**FEDERAL AVIATION ADMINISTRATION
AIRWORTHINESS DIRECTIVES
SMALL AIRCRAFT, ROTORCRAFT, GLIDERS,
BALLOONS, & AIRSHIPS**

BIWEEKLY 2001-08

2001-07-09 MD HELICOPTERS INC: Amendment 39-12175. Docket No. 2000-SW-15-AD. Supersedes Emergency AD 99-26-20, Docket No. 99-SW-89-AD.

Figure 1. Main Rotor Upper Hub Assembly Inspection.

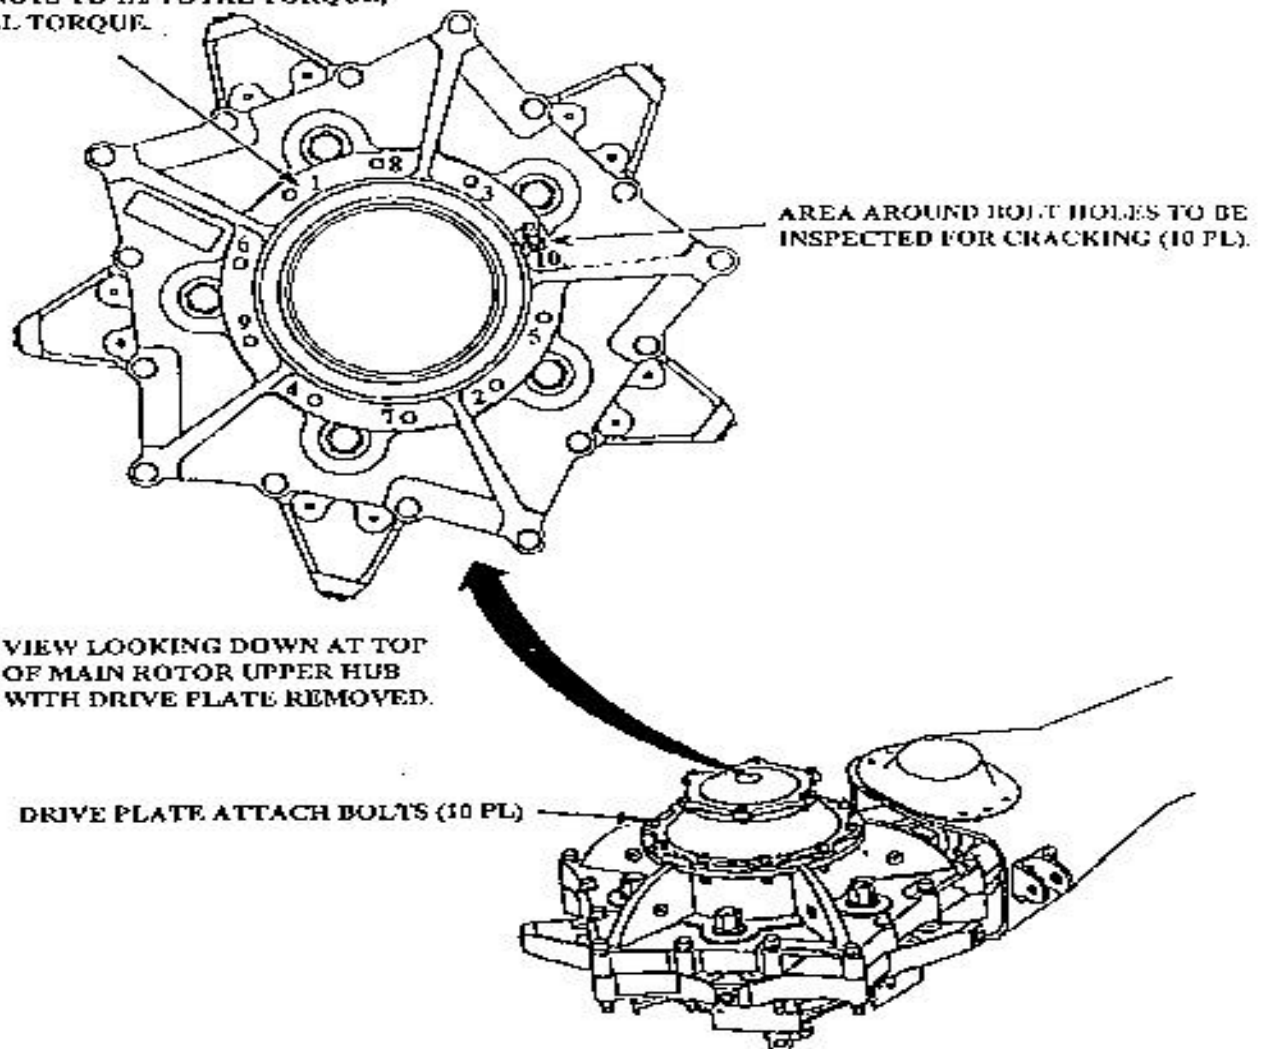
(ii) Mark the main rotor hub holes, bolts, and nuts to correspond with the drive plate hole numbers (see Figure 1).

(v) Using paint stripper (Consumable Item List C313 or equivalent) and cleaning solvent (C420 or equivalent), remove the paint from the upper mating surface of the hub assembly to enable an accurate visual inspection of the drive plate attachment bolt hole (bolt hole) area for cracking (Figure 1). Ensure the paint stripper and solvent DO NOT contaminate the upper bearing and upper grease seal areas.

(viii) Reinstall the main rotor drive plate using 10 new sets of replacement attachment hardware. Torque the nuts to 160 inch pounds above locknut locking/run-on torque in the sequence shown (Figure 1). Record in the rotorcraft logbook, or equivalent record, the locknut locking/run-on torque for each nut.

1. MAIN ROTOR DRIVE PLATE ATTACHMENT
HARDWARE TORQUE SEQUENCE.
2. NUMBERING MAY START AT ANY HOLE.
3. TORQUE NUTS TO 1/2 TOTAL TORQUE,
THEN FULL TORQUE.
